N9950A-01A

Modification Recommended Service Note

N9950A - 32 GHz FieldFox RF analyzer

The Problem – The internal Main Memory (SD) card can fail. Refer to www.keysight.com and the Contact Keysight link.

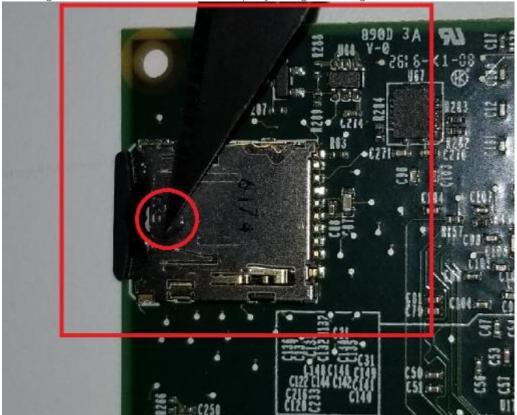
c. Using an Exacto Knife remove the Epoxy bridge holding the SD Card into the SD card socket.

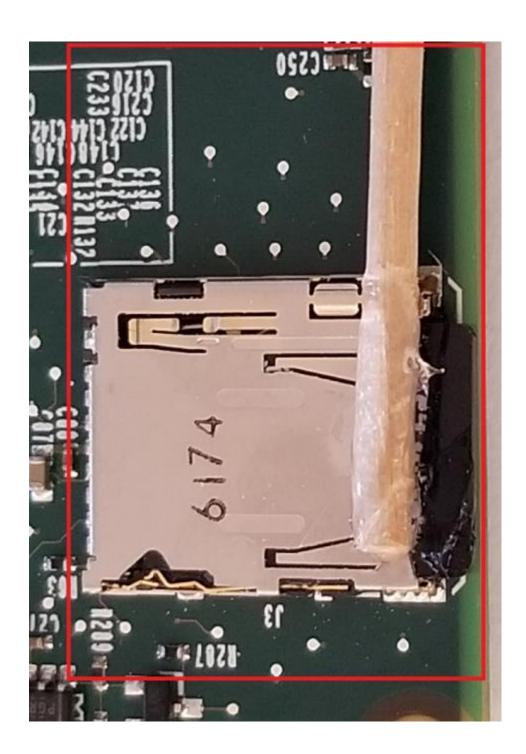
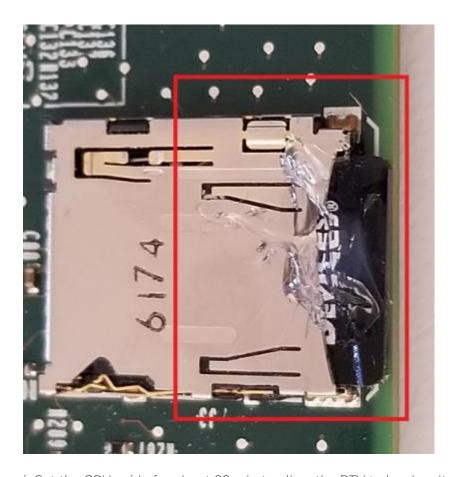
h. It is now necessary to add a small amount of RTV (part number 0470-0450) to bridge the SD card to the SD card socket. Using a wooden Q-Tip place a small amount of RTV on both the SD card and the socket.
